Access Compliance Report

Public Rights-of-Way

Intersection ID: 15932	Main Street: HARTFORD_AV	Cross Street: WESTON_ST	Location:	N
ADA ID: 669E6015E718	Ramp Type: ParaDiag	Initial Pass/Fail: Fail	Overall Compliance: No	Severity Score: 25

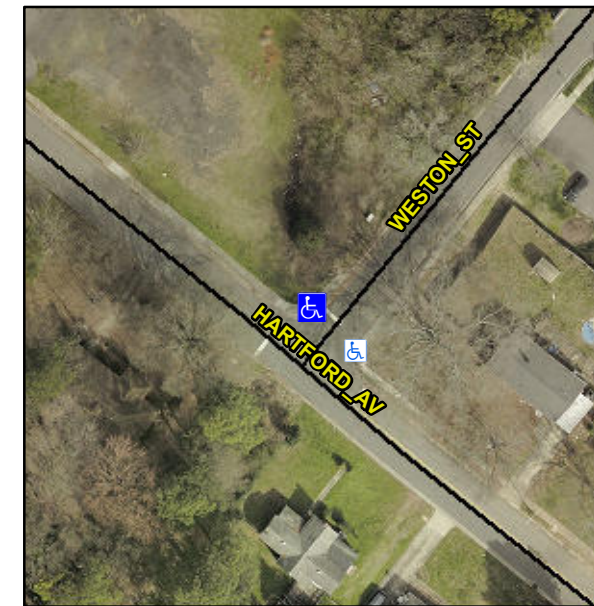
Surveyor Notes:

RT RP < 5%

PROW/ADA:

R304.3.2

Compliance	Description	Data	Compliance	Description	Data
N/A	Ramp Length LT (in)	39.0	N/A	Ramp Length RT (in)	44.0
Yes	Ramp Width LT (in)	61.0	Yes	Ramp Width RT (in)	60.0
No	Ramp Slope LT (%)	14.3	Yes	Ramp Slope RT (%)	4.2
Yes	Ramp XSlope LT (%)	0.5	Yes	Ramp XSlope RT (%)	1.9
N/A	Landing Length (in)	N/A	N/A	DWS Provided?	N/A
N/A	Landing Width (in)	N/A	N/A	DWS Contrast?	N/A
N/A	Landing Slope (%)	N/A	N/A	DWS Length (in)	N/A
N/A	Landing X Slope (%)	N/A	N/A	DWS Full Width?	N/A
N/A	Landing Curb? (Y/N)	N/A	N/A	DWS Offset (in)	N/A
N/A	Shared Landing?	N/A			
N/A	Gutter Ponding?	N/A	N/A	Gutter Slope (%)	N/A
N/A	Gutter Lip Ht (in)	N/A	N/A	Gutter X Slope (%)	N/A
N/A	Painted X Walk1?	No	N/A	Painted X Walk2?	No
	X Walk 1 Direction	To SW		X Walk 2 Direction	To SE
N/A	X Walk 1 Width (in)	N/A	N/A	X Walk 2 Width (in)	N/A
	X Walk 1 Slope (%)	2.4		X Walk 2 Slope (%)	4.9
	X Walk 1 X Slope (%)	3.9		X Walk 2 X Slope (%)	6.7
N/A	Ramp inside XWalk1?	N/A	N/A	Ramp inside XWalk2?	N/A

Possible Solutions:

Remove & Replace Curb Ramp With Two New Directional Ramps or Equivalent.
